## Product Change Notification

**PCN#:** 494

**Change Title:** Product Packaging Change

Model Number	Part Number
FSXLF	501LF-frequency-xxxx

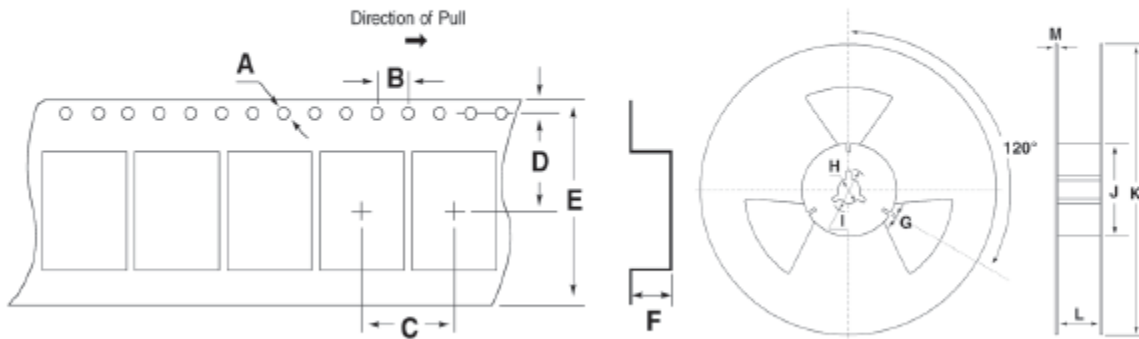
**Description of Change to the Customer:** Tape and reel changes per attached.

Old Specs (highlighted in red)

• TAPE SPECIFICATIONS (millimeters)								• REEL SPECIFICATIONS (millimeters)							
MODEL	A	B	C	D	E	F	STD Reel QTY	MODEL	G	H	I	J	K	L	M
FSXLF	∅1.5	4.0	8.0	7.5	16.0	1.6	3,000	FSXLF	2.0	∅13	∅21	∅50	∅330	16.4	2.0

New Specs (highlighted in green)

• TAPE SPECIFICATIONS (millimeters)								• REEL SPECIFICATIONS (millimeters)							
MODEL	A	B	C	D	E	F	STD Reel QTY	MODEL	G	H	I	J	K	L	M
FSXLF	∅1.5	4.0	4.0	7.5	16.0	1.6	3,000	FSXLF	2.2	∅13	∅21	∅50	∅180	17.0	2.2
